**FINAL DRAINAGE REPORT FOR
HIGH VIEW ESTATES
6665 WALKER ROAD
COLORADO SPRINGS, COLORADO 80908**

March, 2022

PCD File No. MS-222

Review report and remove
duplicate pages.

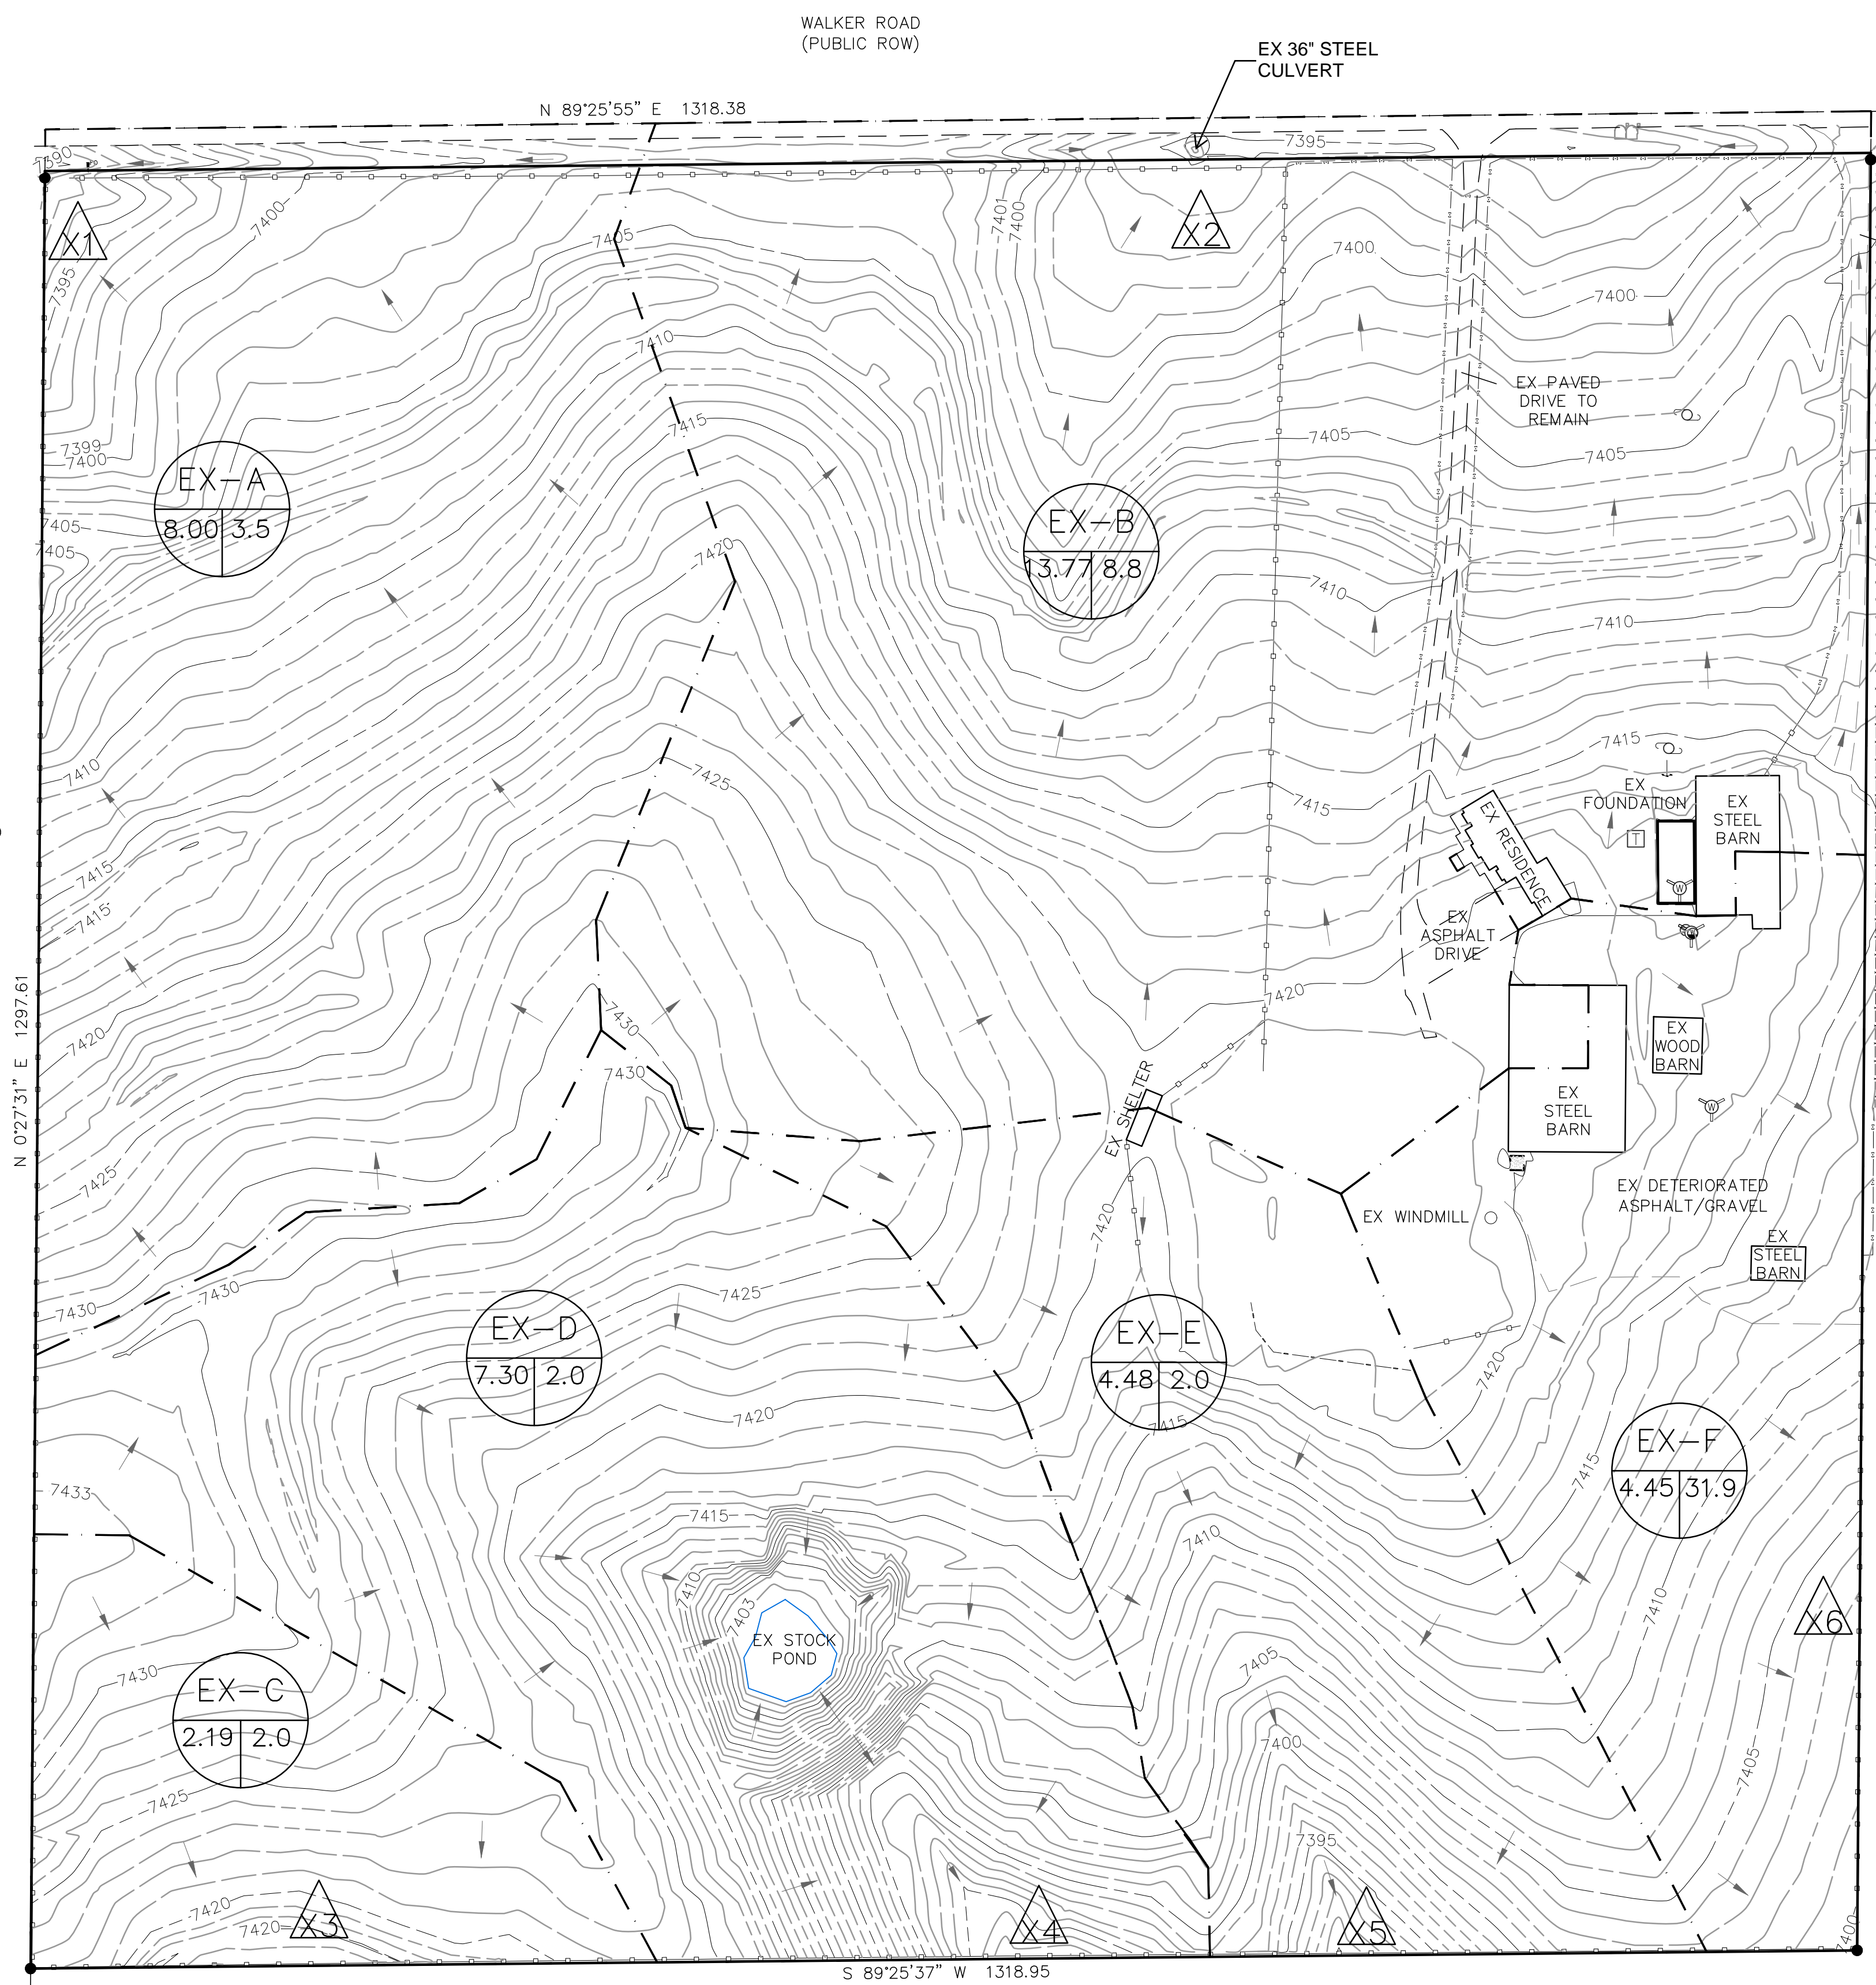
Show time of concentration paths in drainage map.

HIGH VIEW ESTATES
6665 WALKER ROAD
PROPOSED DRAINAGE PLAN

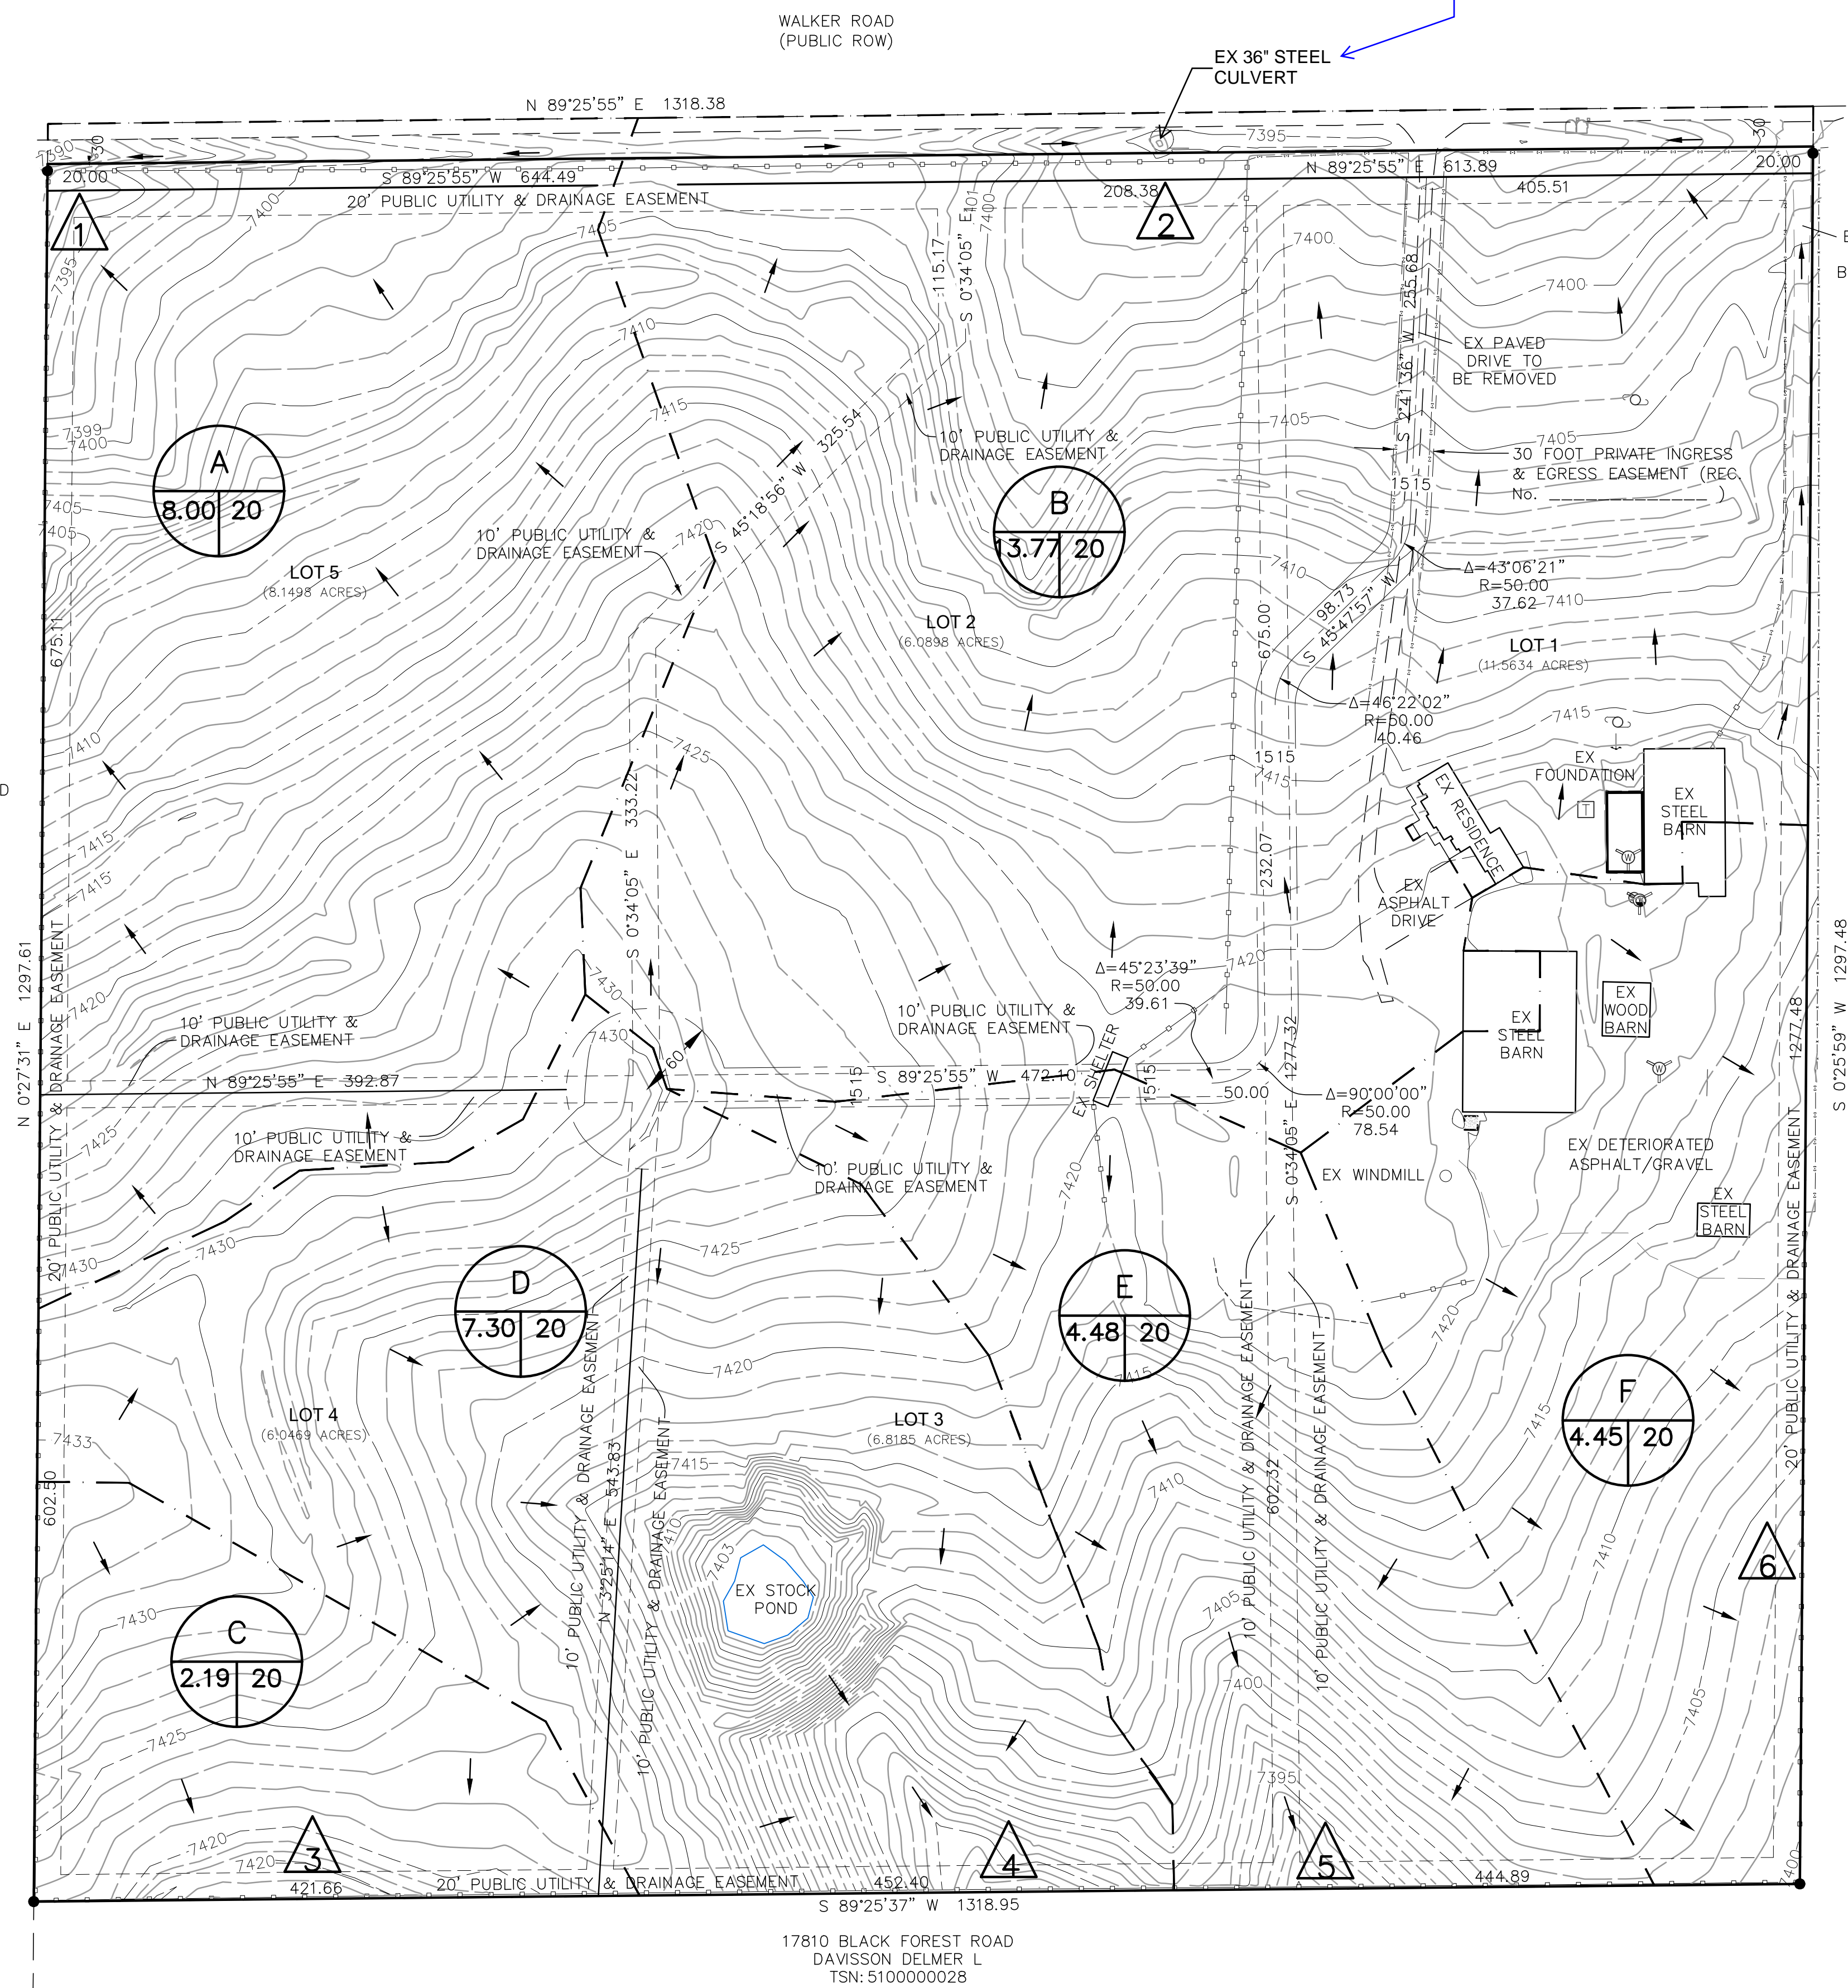
Show time of concentration paths in drainage map.
